TOLEDO - LUCAS COUNTY PLAN COMMISSIONS

REF: SUP-4001-21

SUBJECT: Amendment to a Special Use Permit Originally Granted by Ordinance 503-80 and 977-00, for Gas Station Modifications at 750 E. Central Ave.

SITE PLAN

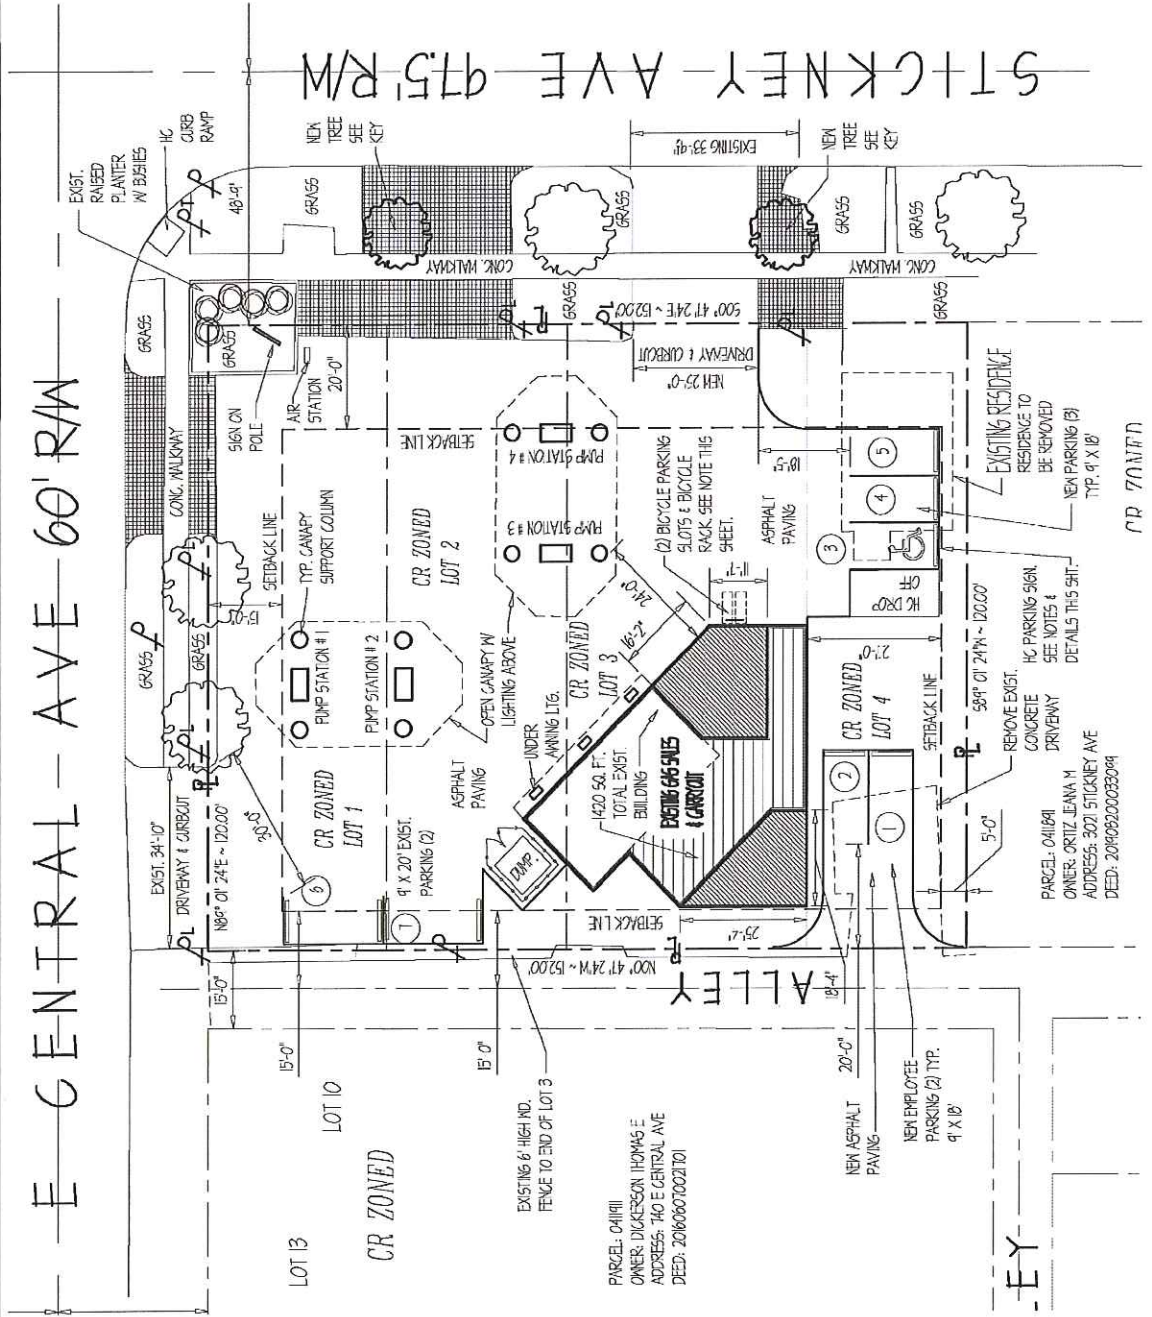
The Division of Transportation has objected to approval of the amendment to the Special Use Permit, citing traffic flow concerns. Required stacking is not shown on the site plan. Per **TMC§1107.1601 - Minimum Number of Spaces**: One (1) stacking space, at least ten-feet (10') by twenty-feet (20') wide is required per pump island. Per **TMC§1107.1911 – Dimensions**: a twenty-five-foot (25') drive aisle is required and is not shown in the site plan, nor are pass-around aisles in the event of pump stacking.

15. All vehicle stacking must be shown for gas pumps and is required to meet TMC 1107
16. A 25' drive aisle is required for two-way traffic per TMC 1107. (That requirement is with the vehicle stacking at gas pumps).
17. The parallel parking shown will not permit for a 25' drive aisle with gas pump stacking requirements per TMC 1107.
18. A pass around aisle is required around vehicle stacking at gas pumps and must meet TMC 1107.
19. A parking spot is required for the air station and must adhere to TMC 1107.

- a. Plan Commission supports the use of a decorative fence or wall in lieu of the required fifteen (15) feet wide frontage greenbelt. Decorative black wrought iron or black heavy gauge aluminum tube fencing or stone to match the existing planter shall be installed in the landscape areas abutting Central Ave and Stickney ave. Fencing shall be at least four (4) feet in height. Continuous shrubs shall be placed around the perimeter of the parking lot. **Not acceptable as depicted.**

- b. A frontage greenbelt is required and shall include one (1) tree for every thirty (30) feet of frontage. Because the site is existing and being brought closer to compliance, Plan Commission staff is requiring four (4) canopy trees within the frontage greenbelt along Stickney Ave. The two (2) trees shown along Central Avenue are acceptable as presented. (TMC§1108.0202) **Acceptable as depicted.**

- c. In lieu of a Type "A" buffer, a continuous solid privacy fence, made of wood or vinyl, shall be installed along the property lines to screen abutting residential properties. Existing fencing along the western property line shall be repaired and extended to meet this requirement. **Not Acceptable as depicted.**

- d. Dumpster screening shall be provided and shall include a solid masonry wall made of brick to match the building, or a combination of wood or wood-like fencing and solid evergreen landscaping. (TMC§1108.0203.G) **Acceptable as depicted.**

25. Plan Commission shares concerns addressed by Transportation that traffic flow may be insufficient.
26. Pump islands shall be set back a minimum of fifteen (15) feet from the property line (TMC§1104.0903). **Acceptable as depicted.**

SITE PLAN

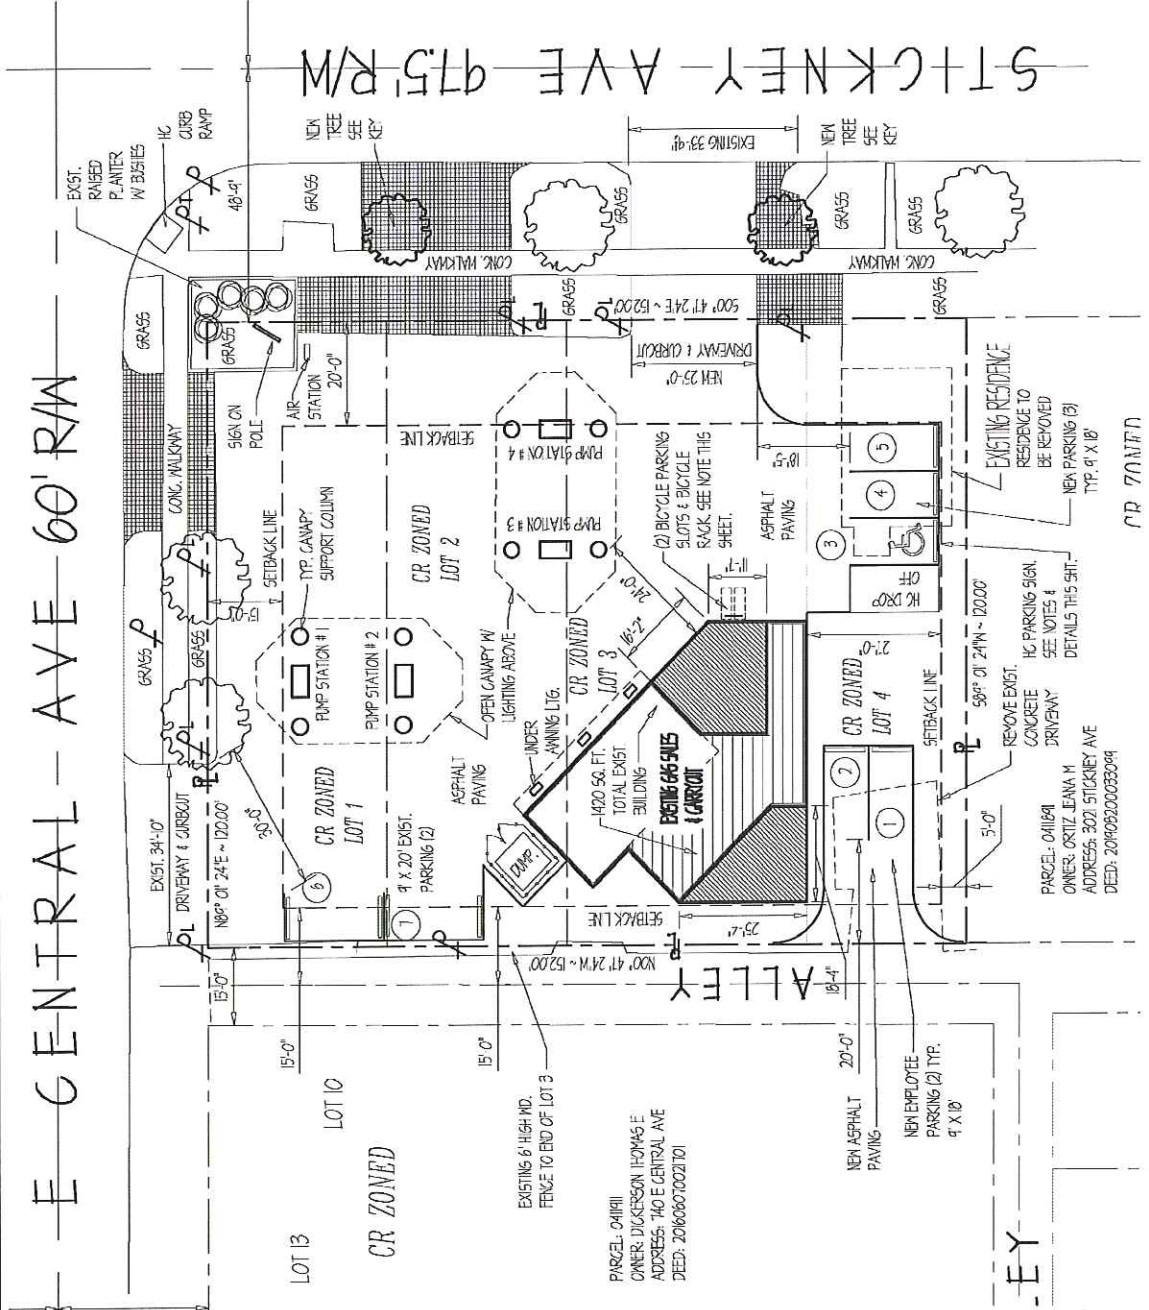
22. Litter receptacles, for the use of parking area users and others, must be provided in off-street parking areas per TMC§1107.1910. Shall be shown on a revised site plan.
